Item Name: Crosstube Turning Detail

DART AEROSPACE LTD	Work Order:	119710
Description: Crosstube Assembly (205/212 High Aft)	Part Number:	D212-664-241
Inspection Dwg: D212-664-241 Rev: D		Page 1 of 2

DRAWING NO. D212-664-241	TITLE CROSSTUBE ASSY (205/212 HI AFT)	REV. D	DART AEROSPACE LTD ENGINEERING ORDER		D.E.O. NO. D212-664-241-D-1	SHEET NO. SHEET 1 OF 2	SCALE NTS
DRAWN	CHECKED	MFG. APPR.	APPROVED	DE APPR.			
DATE 11.04.07	DATE 11.04.11	DATE 11.04.12	DATE 11/04/12	DATE 11.04.12

DRAWING NO. D212-664-241	TITLE CROSSTUBE ASS'Y (205/212 HI AFT)	REV. D	DART AEROSPACE LTD ENGINEERING ORDER		D.E.O. NO. D212-664-241-D-2	SHEET NO. SHEET 1 OF 1	SCALE NTS
DRAWN <i>q</i>	CHECKED <i>ASS</i>	MFG. APPR. <i>SS</i>	APPROVED <i>MD</i>		DE APPR. <i>MD</i>		
DATE 11.07.15	DATE 11.07.20	DATE 11.07.21	DATE 11/27/21		DATE 11.07.21

**D212-664-241/-241B
ASSEMBLY DETAIL**

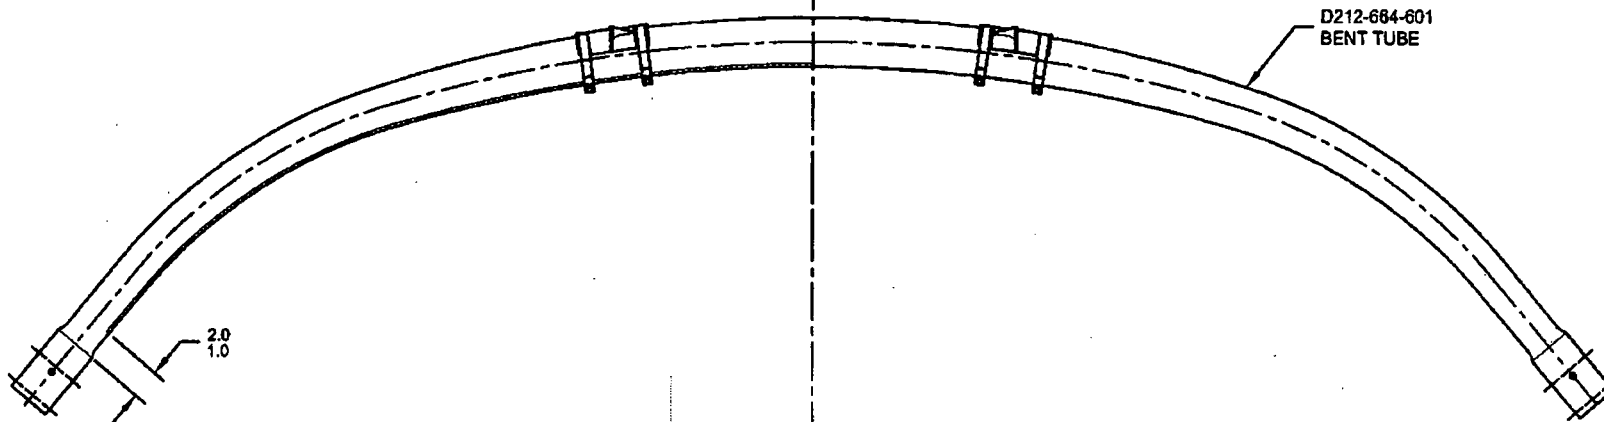
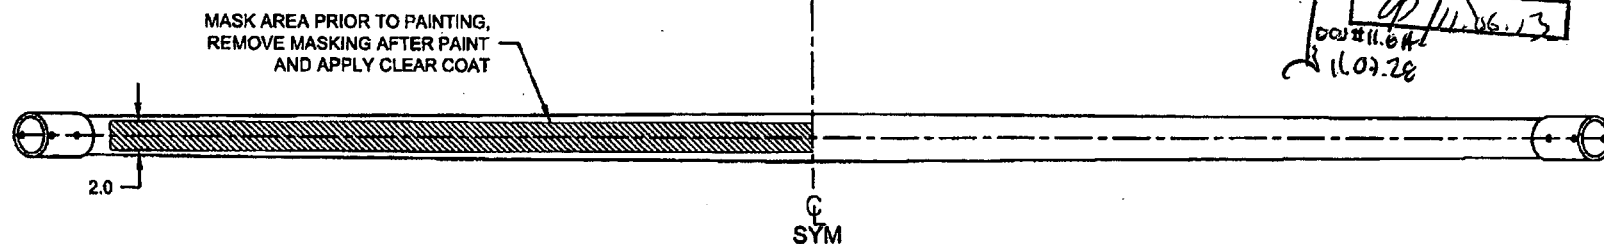
PURPOSE:

ADD AN INSPECTION WINDOW TO UNDERSIDE OF CROSSTUBE.

CHANGE:

NOTES 2 OF SHEET 1 IS AMENDED AS FOLLOWS:

IS:

- 2) FINISH: CHEMICAL CONVERSION COAT PER DART QSI 005 4.1
PRIME INSIDE AND OUTSIDE PER DART QSI 005 4.2
MASK UNDERSIDE OF CROSSTUBE AS SHOWN (HATCHED AREA) AND
PAINT OUTSIDE PER DART QSI 005 4.2
REMOVE MASKING AND APPLY CLEAR COAT

WAS:

- 2) FINISH: CHEMICAL CONVERSION COAT PER DART QSI 005 4.1
PRIME INSIDE AND OUTSIDE PER DART QSI 005 4.2
PAINT OUTSIDE PER DART QSI 005 4.2
